## FSCA-identifier: FA-2021-12-005-LUL-007

Subject: Short center bolt on Universal Twinbar 670 QRH<sup>™</sup>

UNIVERSAL TWINBAR 670 QRH<sup>™</sup> (Quick Release Hook)

### Type of action: Field Safety Notice

Figure 1

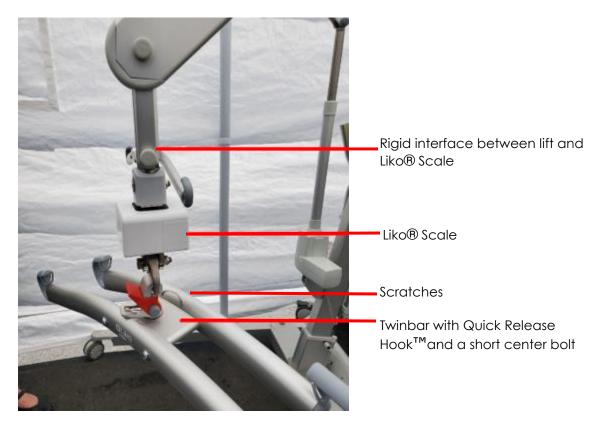
Hillrom has determined that there is a potential for patient fall with the Universal Twinbar 670 QRH<sup>™</sup>, which may have been manufactured with an incorrect, shorter center bolt. The potentially hazardous situation can occur when the Twinbar with the shorter center bolt, is used in combination with a Liko® Scale and a rigid (nonrotating) interface.

See figure 1 below

Hillrom received a report of a patient fall during the use of a Universal Twinbar 670 QRH<sup>™</sup>. The investigation determined the failure to be due to the inability of the quick release hook (QRH) to rotate freely due to contact between QRH and Twinbar (See figure 1 above). The center bolt prevented the Universal Twinbar 670 from swiveling when used in combination with Liko® Scale.

Use of the Twinbar with the short center bolt in combination with the Liko® Scale (see figure 1 above), can result in the inability of free rotation in the Twinbar, which can potentially cause breakage between the Twinbar and the scale. This can potentially result in a patient fall.

Upon receipt of the response form, Hillrom will contact you to arrange to inspect your Twinbar. Should the short bolts be present, your Twinbar will be corrected per intended specification.

Do not use your Universal Twinbar 670 with QRH<sup>™</sup> together with a Liko® Scale until an inspection has been completed.

Figure 2

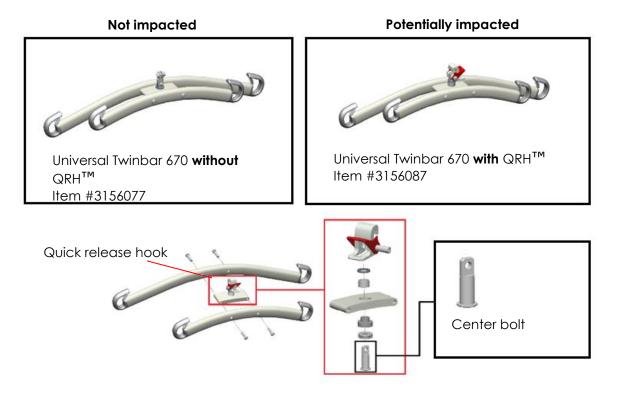
This was determined to be caused by a center bolt of incorrect length (too short) being installed as part of the manufacturing process.

See figure 2 below

Hillrom will arrange to inspect the potentially affected units. If short bolts are identified, your Twinbar will be corrected per intended specification.
